April 11, 2018

RE: **Lot 1 Block 2 Unit 18, S.A.D. 228**
Volcano Cliffs Subdivision
6616 Petirrojo Rd. NW
Grading and Drainage Plan
Engineers Stamp Date; 2-9-18 (D10D003G2)
Pad Certification Date; 4/7/18

James D. Hughes, P.E.
Principal Engineer, Hydrology
Planning Department

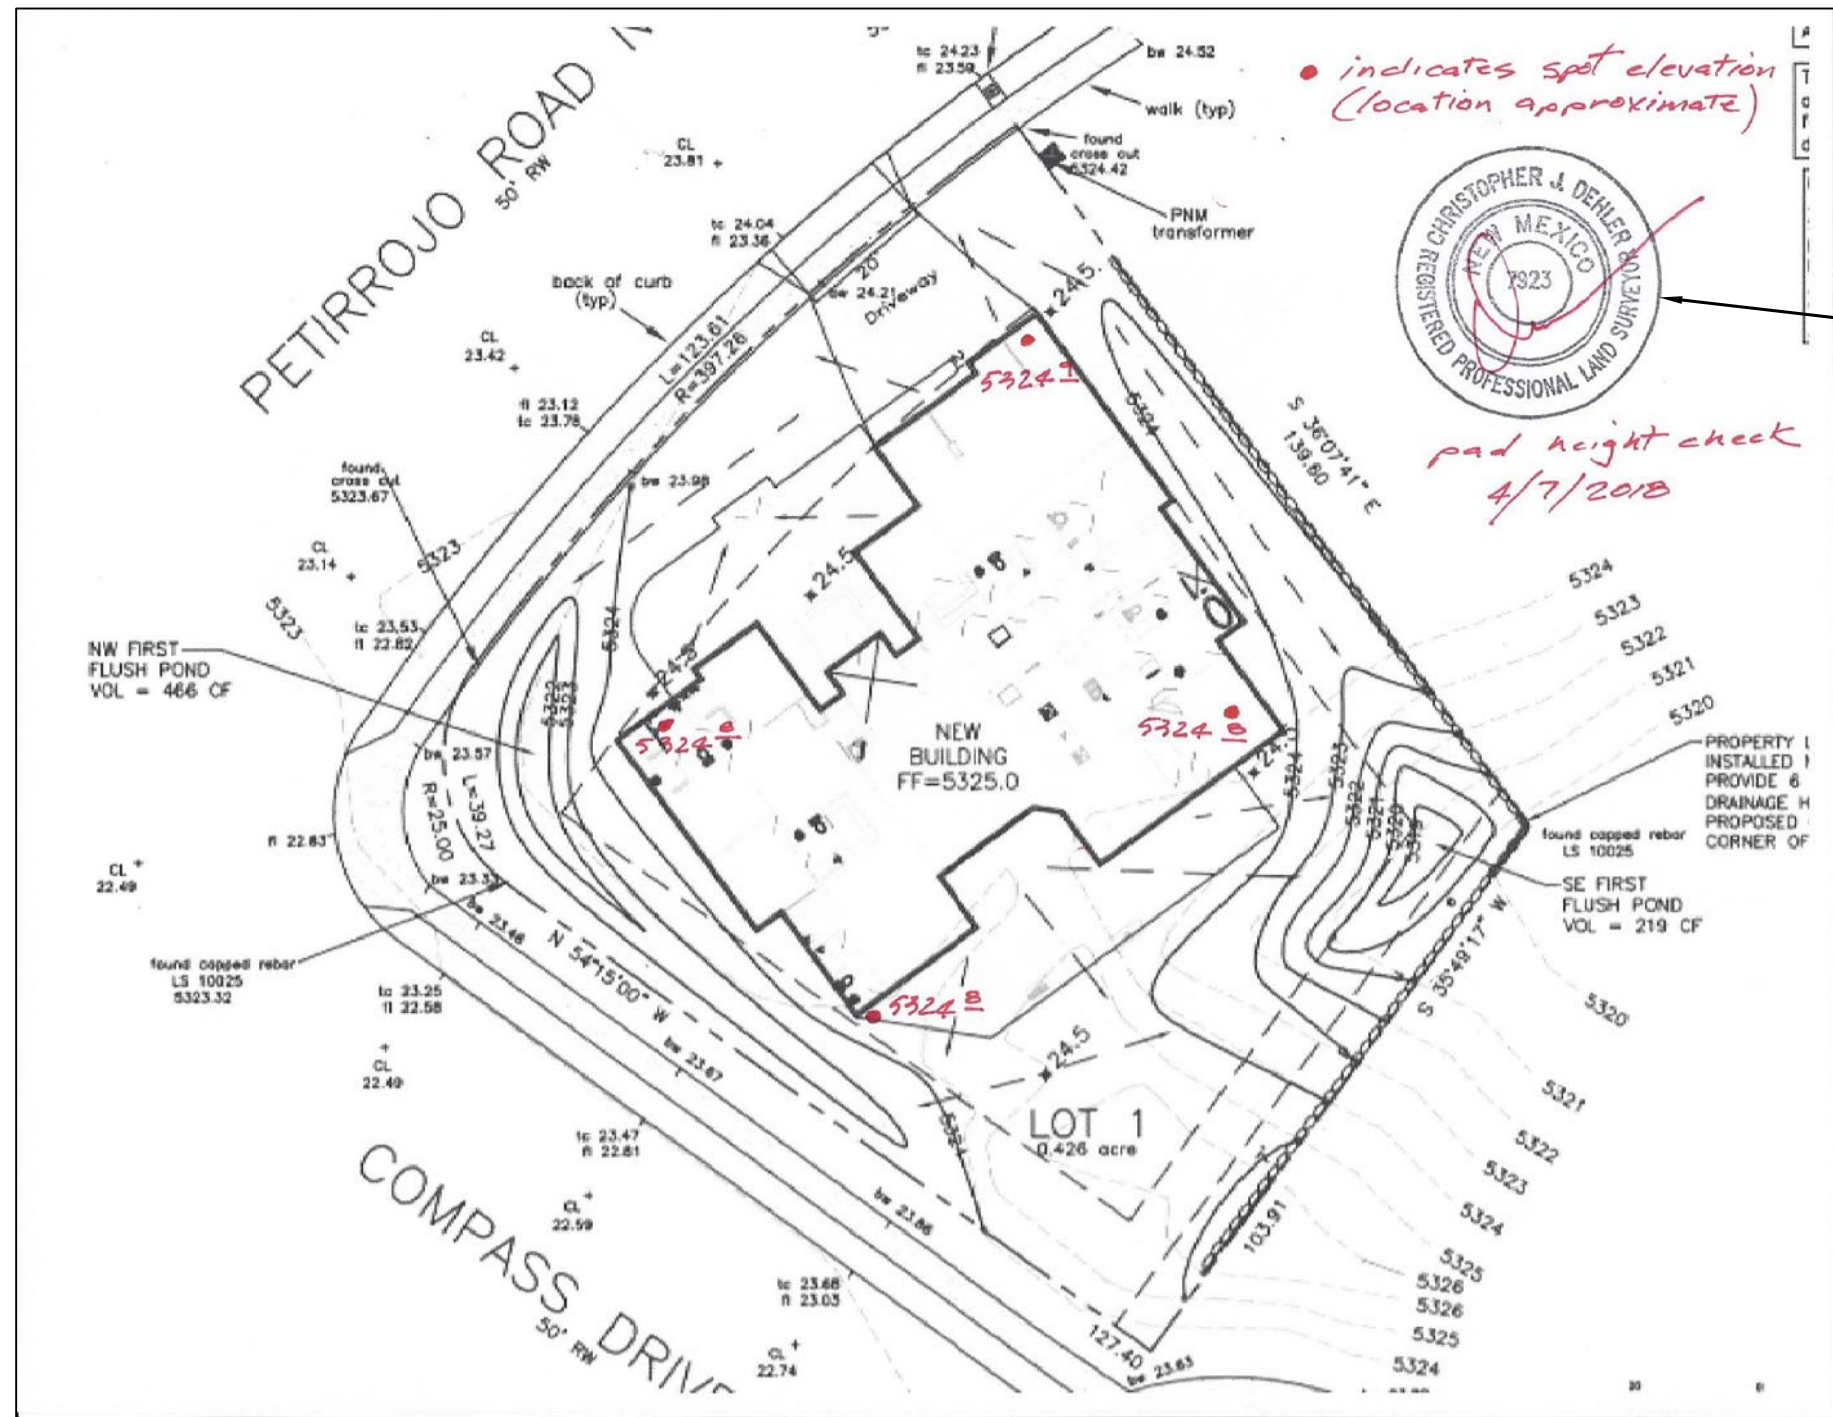
Based upon the information provided in your submittal received 4/10/18, this plan is approved for Building Permit.

Please have the owner/builder attach a copy of this approved plan, to the construction sets in the permitting process prior to sign-off by Hydrology. Reiterate to the Owner/Contractor that a separate permit for a garden/retaining wall must be obtained, with the approved G&D plan dated 2/9/18.

Prior to Certificate of Occupancy release, Engineer Certification per the DPM checklist of this plan will be required.
